### **Proposal for Supplement 41 to 03 series of amendments to Regulation No. 37 (Filament lamps)**

#### **Submitted by the expert from the Working Party "Brussels 1952"\***

The text reproduced below was prepared by the expert from the Working Party "Brussels 1952" (GTB) introducing into Regulation No. 37, a new category of amber dual filament light sources PY21/5W. The modifications to the existing text of the Regulation are marked in bold for new or strikethrough for deleted characters.

Sheet PY21/5W/1

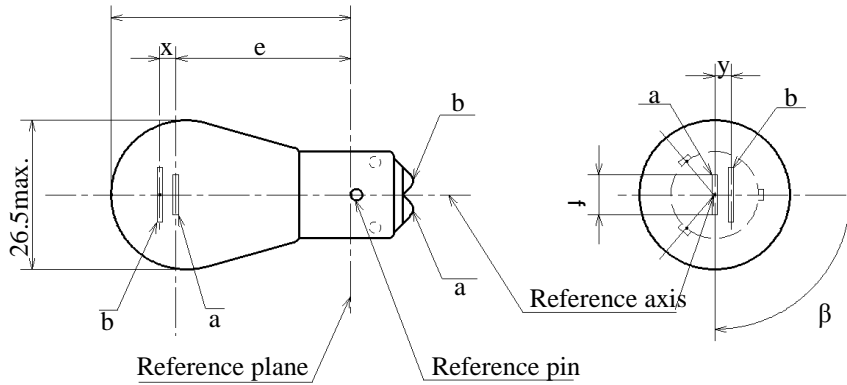
*Insert new sheets PY21/5W/1 to 3, between sheet PY21W/1 and sheet PY27/7W/1, to read: (see next pages)*

The drawings are intended only to illustrate the essential dimensions (in mm) of the filament lamp

<i>Dime</i>				rd filament lamp
e				4/
f				28.6 ± 0.3
Lateral deviat				7.0 + 0/- 2
x, y				0.3 max.
β				2.8 ± 0.3
[Cap BA15d-3				90° ± 5°
Electrical and photometric characteristics				
Rated values	Volts	12		12
	Watts	21	5	21/5
Test voltage	Volts	13.5		13.5
Objective values	Watts	26.5 max.	6.6 max.	26.5 and 6.6 max.
	Luminous flux	270	21	
	± %	20	20	
Reference luminous flux at approximately 13.5 V				White: 440 lm and 35 lm Amber: 270 lm and 21 lm

1/ These dimensions shall be checked by means of a "box-system". See sheets PY21/5W/2 and PY21/5W/3. "x" and "y" refer to the major (high-wattage) filament, not to the reference axis.  
 2/ Maximum lateral deviation of the major (high wattage) filament centre from two mutually perpendicular planes both containing the reference axis and one containing the axis of the reference pin.  
 3/ The light emitted from normal production lamps shall be amber (see also note 4/).  
 4/ The light emitted from standard filament lamps shall be white or amber.
